**INTERPRETATION IC 135-2024-1 OF  
ANSI/ASHRAE STANDARD 135-2024 BACnet® -  
A Data Communication Protocol for Building  
Automation and Control Networks**

Approval Date: February 8, 2025

**Reference:** This request for interpretation refers to ANSI/ASHRAE Standard 135-2024, Sections 3.2 and 4.2, pertaining to use of the term **bridge**. Specifically, how a wireless bridge would interoperate on an MS/TP segment as defined in Clause 9.

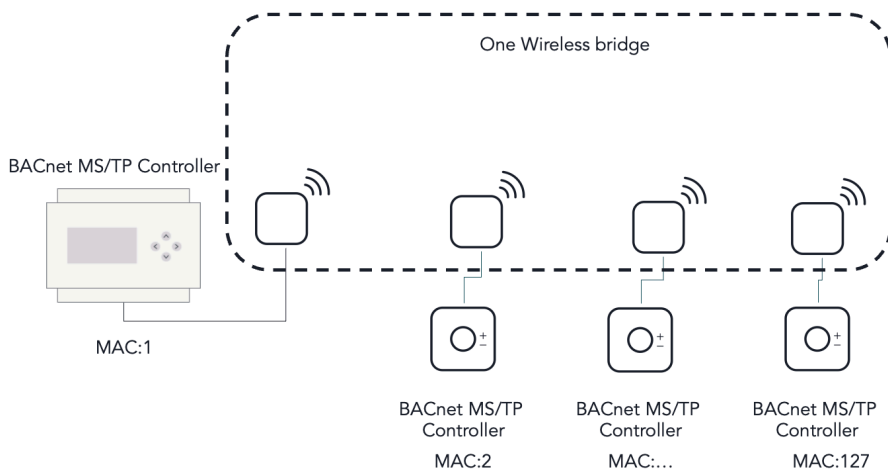
**Background:** The BACnet standard does not define which mediums that are allowed or not allowed within the concept of a network bridge, only that they connect two or more segments at the physical and data link layers. This interpretation request aims to get a clearer definition of how a bridge is permitted to operate within the confines of a MS/TP network segment. The following is an example of a schematic of a wireless mesh network within the concept of a bridge.
